AMENDMENT OF SOLICITATION/MODIFICATION OF CONTRACT				1. CONTRACT ID CODE See Block #2		PAGE OF PAGES 1 of 6		
2. AMENDMENT/MODIFICATION NO. N66001-02-R-5017 0003			3. EFFECTIVE DATE 17 Jun 2002		4. REQUISITION/PURCHASE REQ.NO.		5. PROJECT NO. (If applicable)

FOR Questions and Answers (Q&A's) and administrative changes
Regarding SSC-SD RFP N66001-02-R-5017, entitled "Secure Digital Communication Control System."

MTRACS Console Rear View

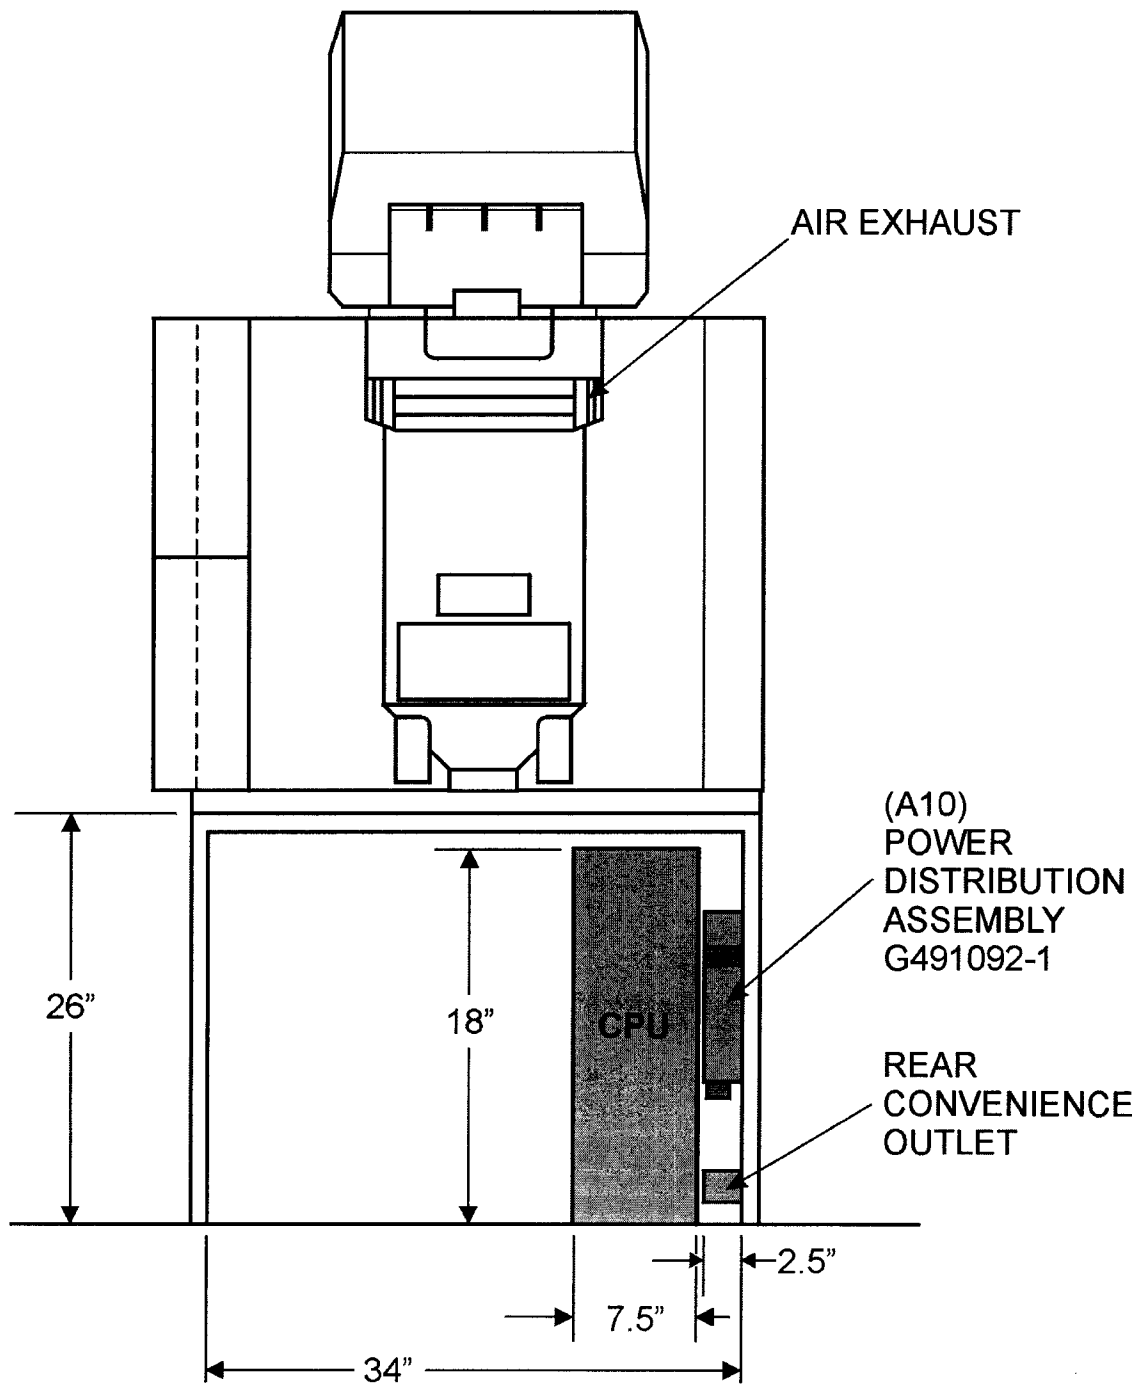
1. Review of the MTRACS Console Drawing does not provide enough information as to the space available for mounting the LCD Screens, Speakers, Jackbox(s) or other ancillary equipment that may be required for an operational position. Are dimensions particular to sizes of openings including height, width, and depth for mountings of these equipment's in the console available?

Government Response: See the attached drawing.
